**CITY OF TEMPE
DEVELOPMENT REVIEW COMMISSION**

Meeting Date: 03/22/2016
Agenda Item: 3

ACTION: Request for a Development Plan Review consisting of a new church building for **GETHSEMANE LUTHERAN CHURCH**, located at 1035 East Guadalupe Road. The applicant is Mark Phillips of CCBG Architects, Inc.

BACKGROUND INFORMATION: **GETHSEMANE LUTHERAN CHURCH (PL160012)** consists of three separate parcels zoned agricultural and used for school and place of worship uses. Each parcel meets individual development standards for the existing buildings on site, but is developed as a unified site with shared parking, retention, landscape, amenities and utilities. The existing sanctuary is being expanded on the eastern lot adjacent to Terrace Road. The courtyard between the existing sanctuary and family life center is being remodeled, and the existing drive and parking area between the school buildings on the west end of the site, adjacent to commercial uses, is being remodeled as a shaded playground for the school. The request includes the following:

Drawn: RL
Checked: P.J.L.
Job Number: 1426
Drawing: SITE PLAN
Sheet: A1.1

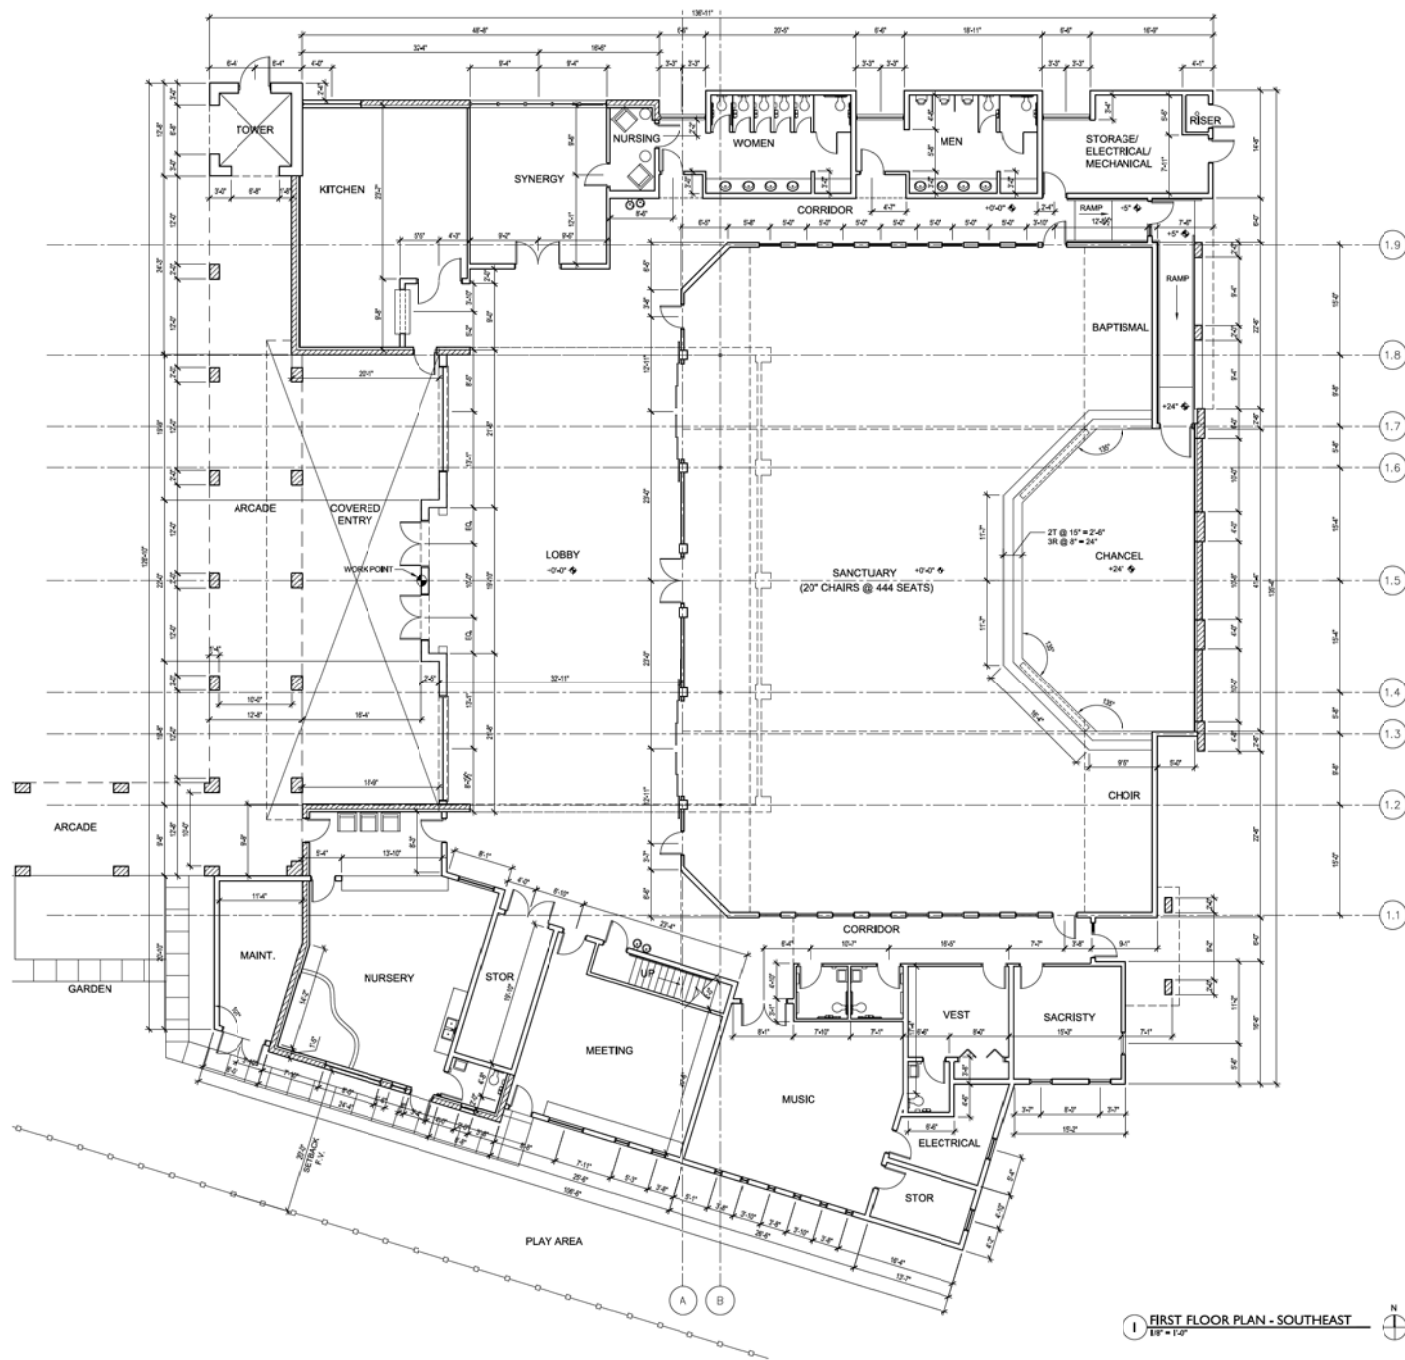
3. Provide service yard and mechanical yard walls that are at least 8'-0" tall as measured from adjacent grade and are at least the height of the equipment being enclosed, whichever is greater. Verify height of equipment and mounting base to ensure that wall height is adequate to fully screen the equipment.

4. Provide gates of steel vertical picket, steel mesh, steel panel or similar construction. Where a gate has a screen function and is completely opaque, provide vision portals for visual surveillance. Provide gates of height that match that of the adjacent enclosure walls. Review gate hardware with Building Safety and Fire staff and design gate to resolve lock and emergency ingress/egress features that may be required.

6. Place exterior, freestanding reduced pressure and double check backflow assemblies in pre-manufactured, pre-finished, lockable cages (one assembly per cage). If backflow prevention or similar device is for a 3" or greater water line, delete cage and provide a masonry or concrete screen wall following the requirements of Standard Detail T-214.

- Correctly indicate clear vision triangles at both driveways on the site and landscape plans. Identify speed limits for adjacent streets at the site frontages. Begin sight triangle in driveways at point 15'-0" in back of face of curb. Consult Intersection Sight Distance memo, available from Traffic Engineering if needed www.tempe.gov/index.aspx?page=801 . Do not locate site furnishings, screen walls or other visual obstructions over 2'-0" tall (except canopy trees are allowed) within each clear vision triangle.

- FIRE:
 - Clearly define the fire lanes. Ensure that there is at least a 20'-0" horizontal width, and a 14'-0" vertical clearance from the fire lane surface to the underside of tree canopies or overhead structures. Layout and details of fire lanes are subject to Fire Department approval.

- SOLID WASTE SERVICES:
 - Enclosure indicated on site plan is exclusively for refuse. Construct walls, pad and bollards in conformance with standard detail DS-116.

Sheet
A3.1

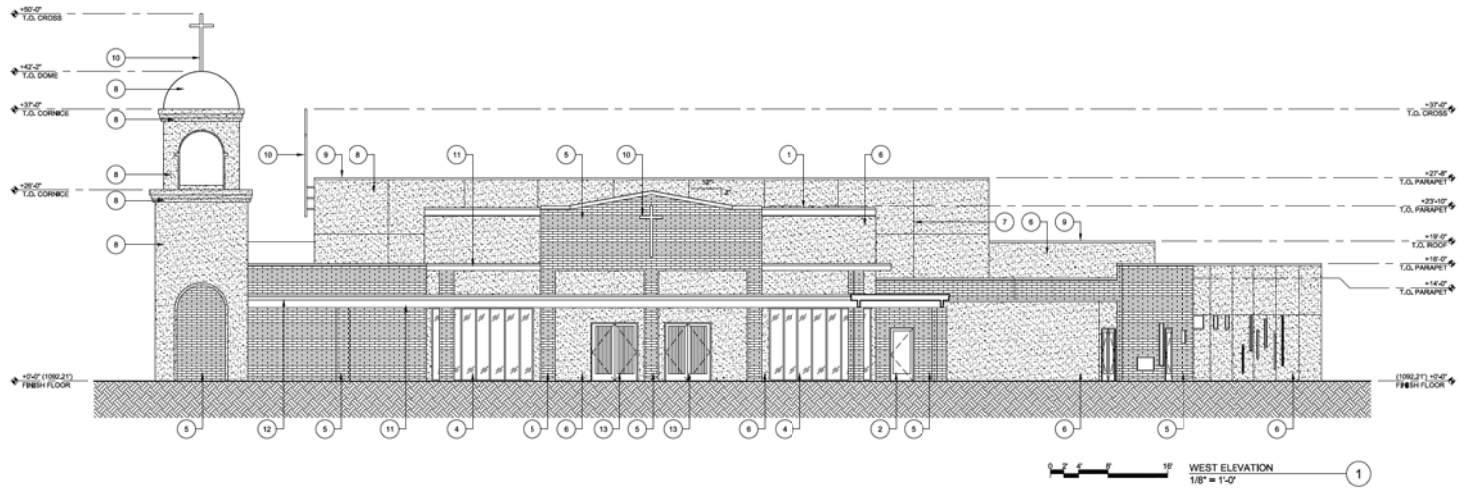
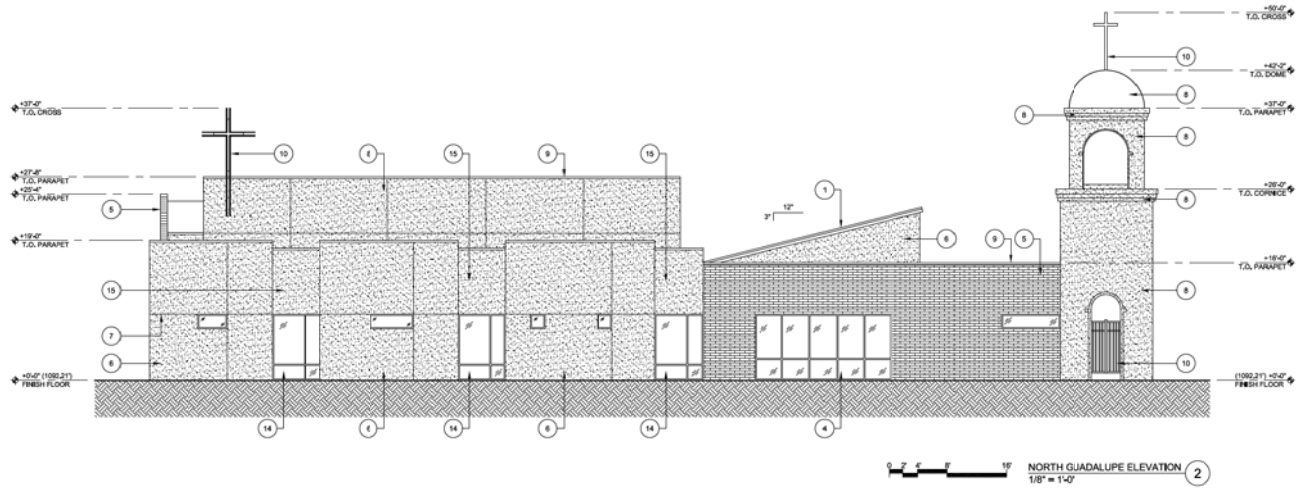
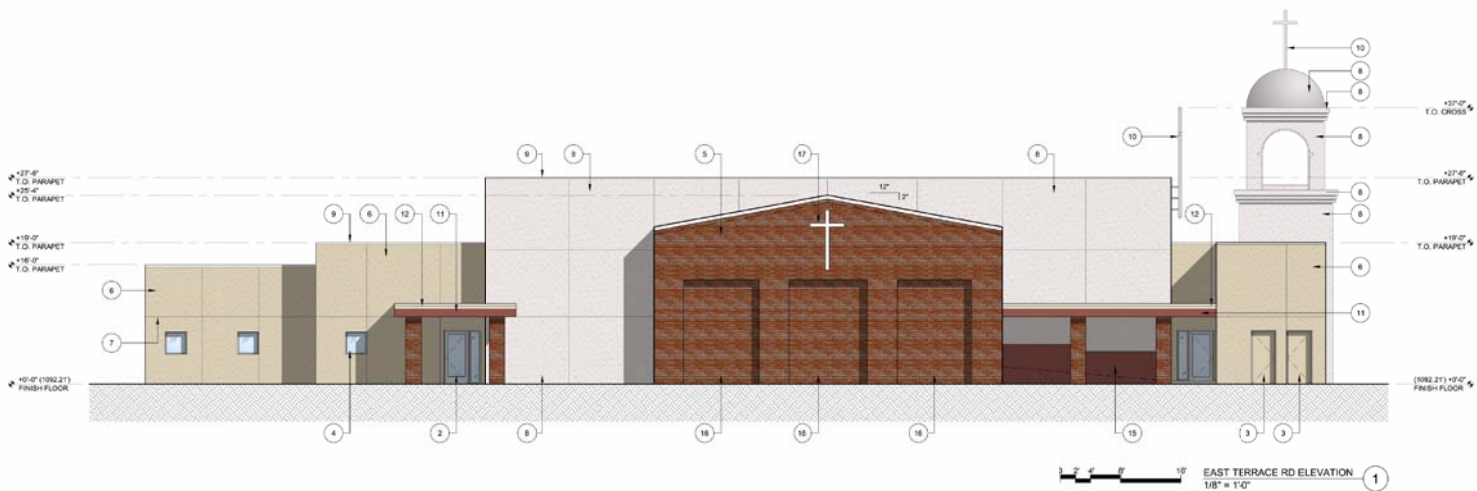
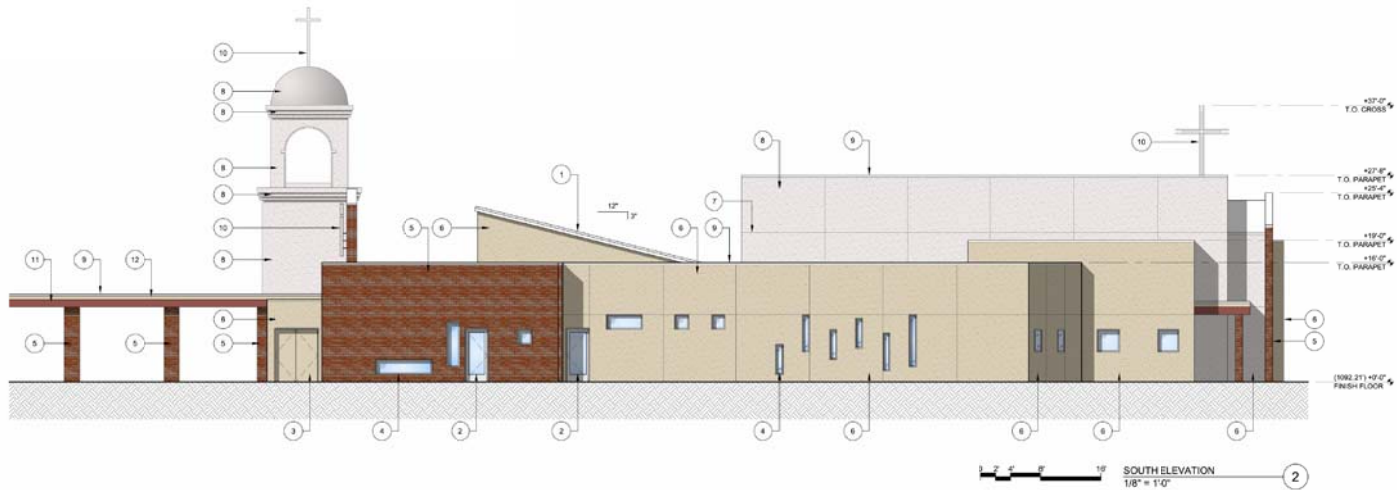
8. The materials and colors are approved as presented March 4, 2016:
 - Roof – flat with parapet
 - Primary Building – Stucco corduroy finish painted Dunn Edwards DE6171 Sand Dollar (tan)

- Secondary Building – Stucco sand finish painted Dunn Edwards DEW397 Angel Feather (beige)
 - Tertiary Building – Exposed CMU 4" x 8" x 16" Highland Founders Block Superlite product or equivalent

- Aluminum Storefront Windows with Blue Tinted Glazing
 - Cross, Gates and metal accents – painted steel Silver 1c530-1201 Ominithane
 - Metal Canopy – painted steel Dunn Edwards DET 430 Mesa Red (rust/brick red)

- Wood doors – Red Oak RA-17533 Algoma Hardwoods
 - 3" coping on all parapets
 - Provide primary building colors and materials with a light reflectance value of 75 percent or less. Additions or modifications may be submitted for review during building plan check process.

9. Provide secure roof access from the interior of the building. Do not expose roof access to public view.
10. Conceal roof drainage system within the interior of the building.

PRELIMINARY - NOT FOR CONSTRUCTION
PL-1 of 1

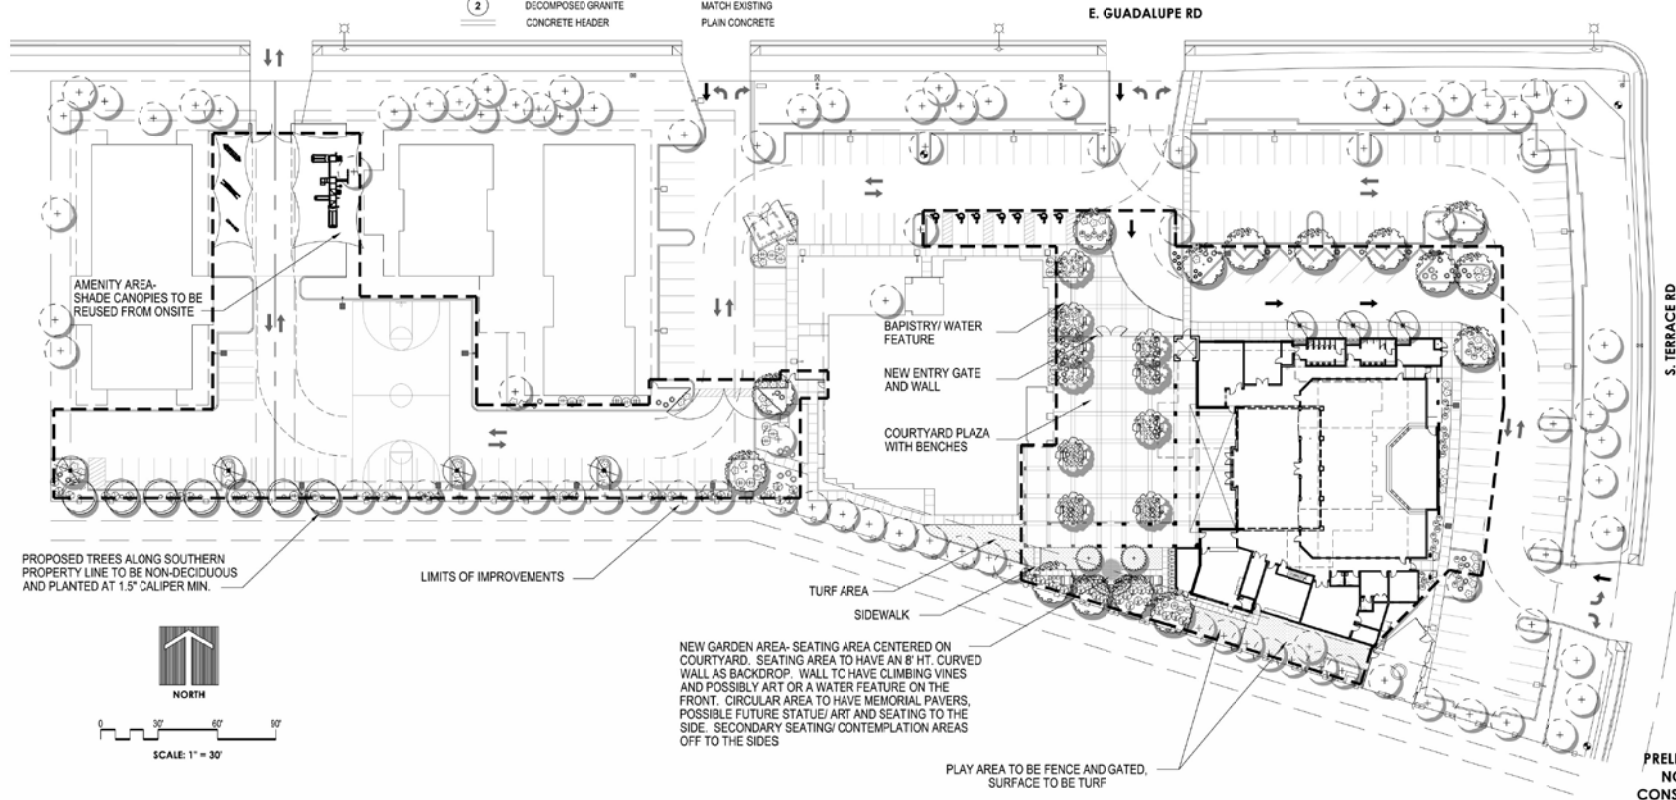
16. Arterial street trees shall be a minimum of 36" box specimens and a minimum of 1 ½" caliper trunk.
17. Irrigation notes:
 - a. Provide dedicated landscape water meter.

- b. Provide pipe distribution system of buried rigid (polyvinylchloride), not flexible (polyethylene). Use of schedule 40 PVC mainline and class 315 PVC ½" feeder line is acceptable. Class 200 PVC feeder line may be used for sizes greater than ½". Provide details of water distribution system.

19. Top dress planting areas with a rock or decomposed granite application. Provide rock or decomposed granite of 2" uniform thickness. Provide pre-emergence weed control application and do not underlay rock or decomposed granite application with plastic.

20. Trees shall be planted a minimum of 20'-0" from any existing or proposed public water or sewer lines. The tree planting separation requirements may be reduced from the waterline upon the installation of a linear root barrier, a minimum of 6'-0" parallel from the waterline, or around the tree. The root barrier shall be a continuous material, a minimum of 0.08" thick, installed 0'-2" above finish grade to a depth of 8'-0" below grade. Final approval subject to determination by the Public Works, Water Utilities Division.
